MASTER PLAN DESIGN REGULATIONS
~~2025~~September 8, 2025

MASTER PLAN DESIGN REGULATIONS
2025September 8, 2025

~~AMENDED~~ TREE DISPOSITION AND MITIGATION PLAN

EXHIBIT F ~~AMENDED~~ LANDSCAPE PHASING PLAN

Typical Root Barrier Detail

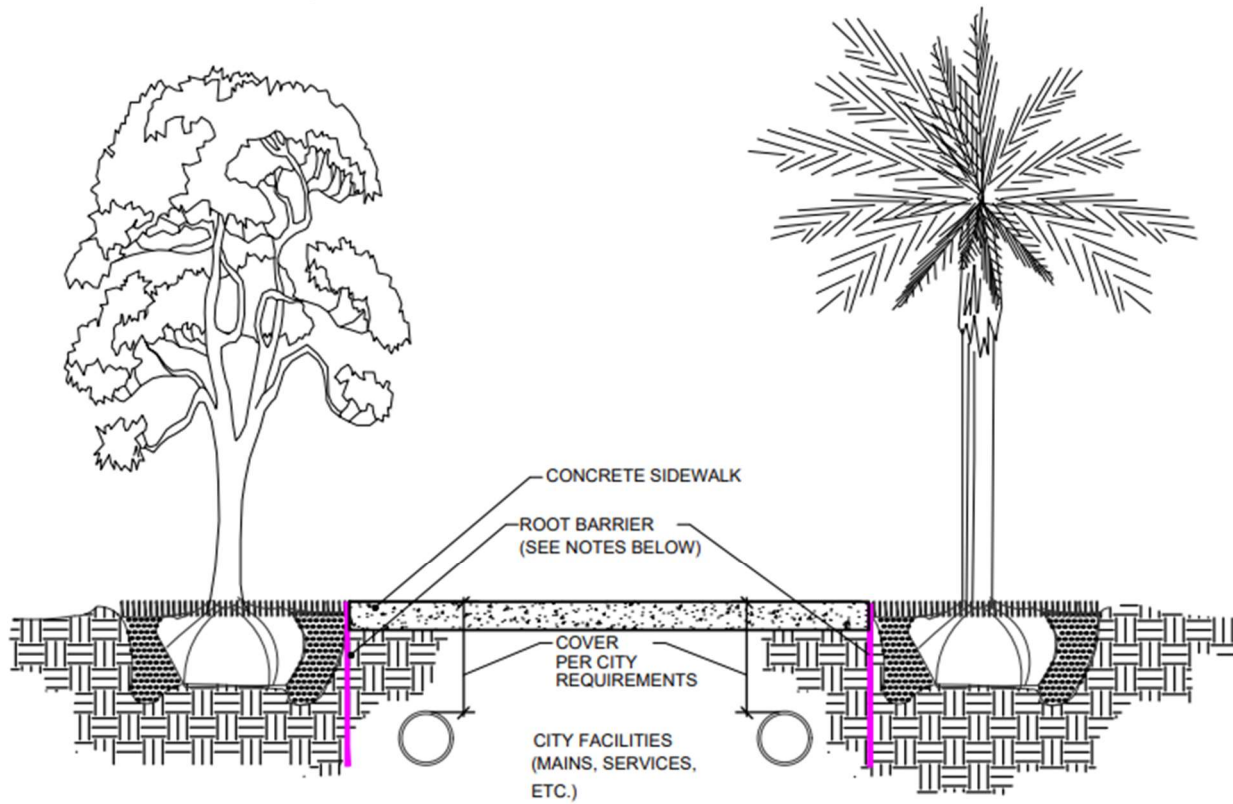
PROVIDE ROOT BARRIERS AS REQUIRED ON ALL TREES IN CONFLICT WITH MINIMUM CLEARANCE WITH UTILITIES. MINIMUM CLEARANCE OF 5' FT FOR PALMS AND SMALL TREES AND 10' FT FOR LARGE TREES WITH INTRUSIVE ROOT SYSTEMS PER CITY REQUIREMENTS. SEE TYPICAL DETAIL BELOW.
